6 SUB2008-00201

BELLE ISLE SUBDIVISION, UNIT THREE RESUBDIVISION OF LOTS 2 & 7

The purpose of this application is to combine two legal lots of record into one lot.

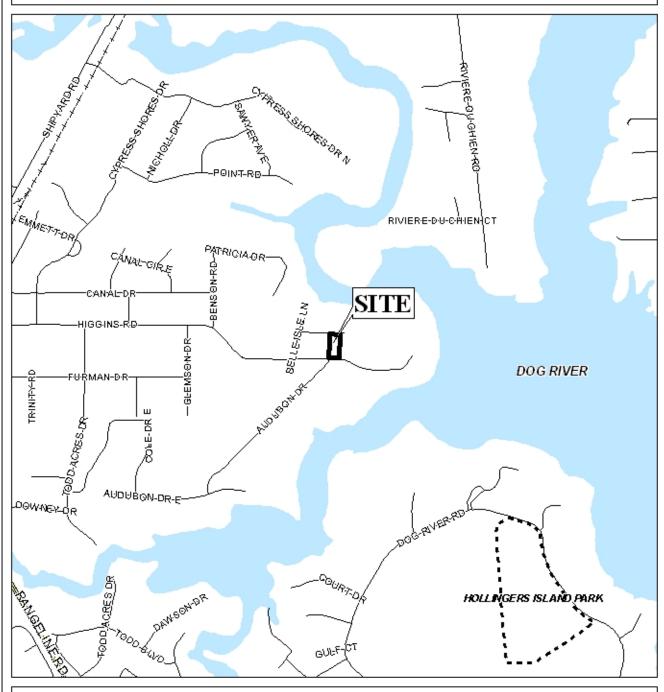
The site fronts Belle Isle Lane North to the North and Higgins Road to the South. Higgins Road is a paved, minor street with sufficient right-of-way. However, Belle Isle Lane North is unpaved and gravel and does not have a curb and gutter; thus, the plat should be revised to provide a minimum 30' from the centerline of Belle Isle Lane North. Furthermore, the plat submitted by the applicant has Belle Isle Lane North labeled as "Belle Isle Lane East," which should also be addressed prior to signing the final plat.

The site has approximately 150' of frontage along both streets. As this is a residential subdivision, the lot should be denied direct access to Belle Isle Lane North and limited to the existing curb cut to Higgins Road.

There is no depiction of the minimum building setback line along Belle Isle Lane North, which should be addressed prior to signing the final plat.

The plat meets the minimum size requirement for developments with access to public water and sewer. However, it is requested that the applicant revise the preliminary plat to label the lot with its size in square feet, or provide a table on the plat with the same information.

- 1) dedication of sufficient right-of-way to provide a minimum 30' as measure from the centerline of Belle Isle Lane North;
- 2) revision of the plat to correctly label Belle Isle Lane North;

- 3) placement of a note on the final plat stating that the lot is denied direct access to Belle Isle Lane North and limited to the existing curb cut to Higgins Road;

- 4) labeling of the lot with its size in square feet, or the provision of a table on the final plat with the same information;
- 5) depiction of the 25' minimum building setback line along Belle Isle Lane North;
